Well Name: DEEP ELEM 4 FED COM	Well Location: T26S / R31E / SEC 4 / SWSE /	County or Parish/State:
Well Number: 727H	Type of Well: OIL WELL	Allottee or Tribe Name:
Lease Number: NMNM0438001	Unit or CA Name:	Unit or CA Number:
US Well Number: 3001548555	Well Status: Approved Application for Permit to Drill	Operator: EOG RESOURCES INCORPORATED

Notice of Intent

Procedure Description: EOG respectfully requests an amendment to our approved APD for this well to reflect the following changes: Change SHL to T-26-S, R-31-E, Sec 4, 408' FSL, 1998' FEL, Eddy Co., N.M. Change BHL to T-26-S, R-31-E, Sec 16, 230' FSL, 2630' FEL, Eddy Co., N.M.

Revised Permit Information 06/10/2021:

Revised Wellbore

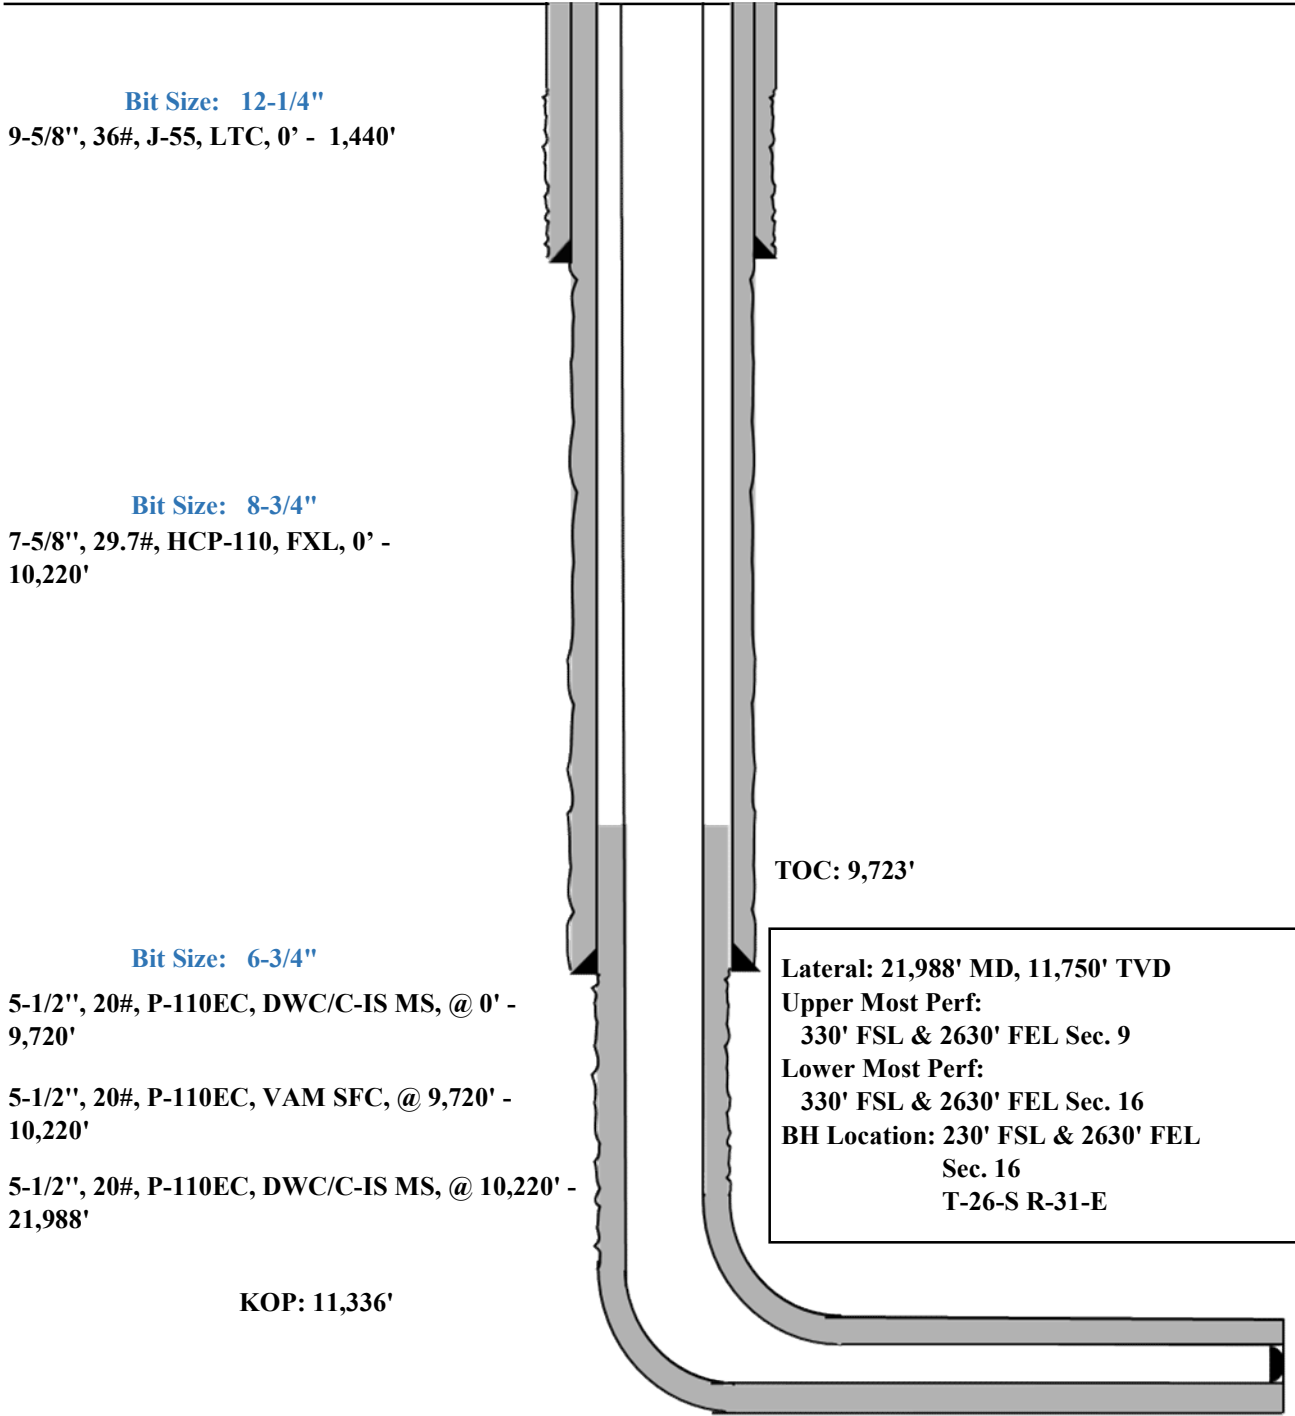
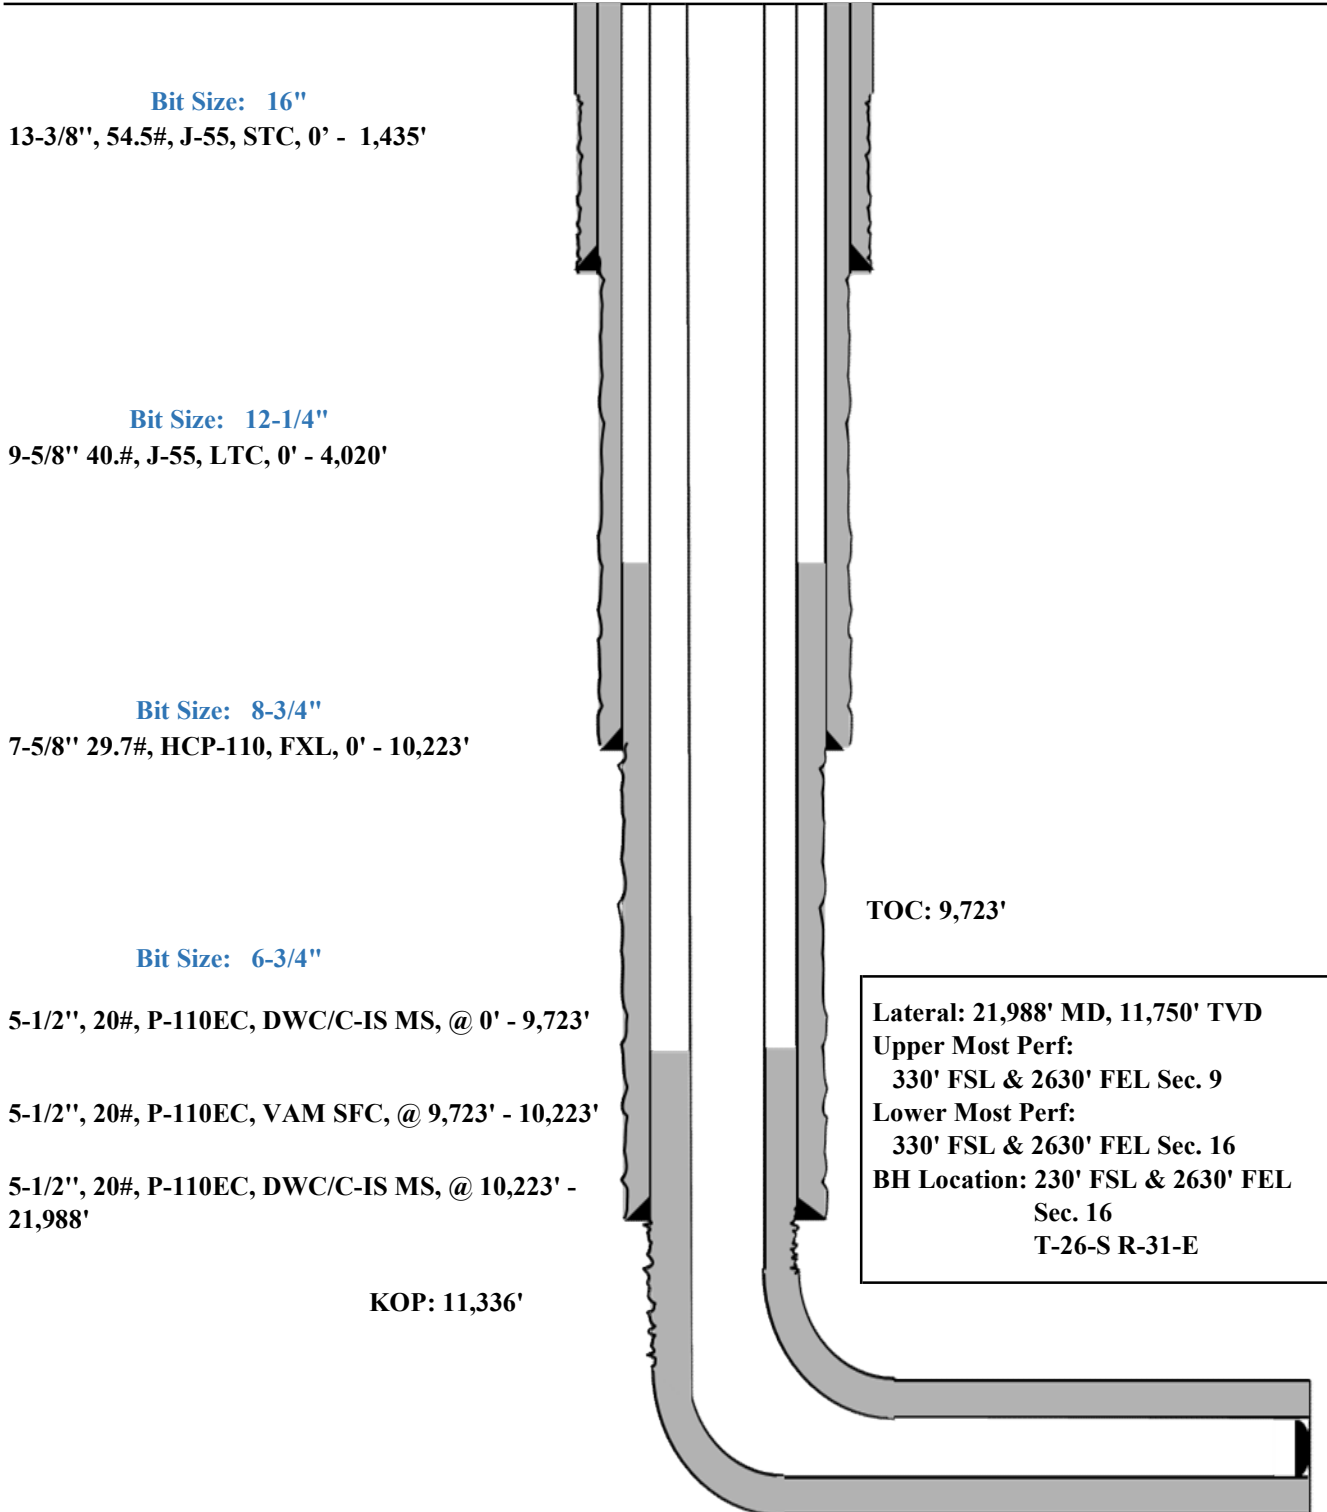
Location: SHL: 408' FSL & 1998' FEL, Section 4, T-26-S, R-31-E, Eddy Co., N.M.

BHL: 230' FSL & 2630' FEL, Section 16, T-26-S, R-31-E, Eddy Co., N.M.
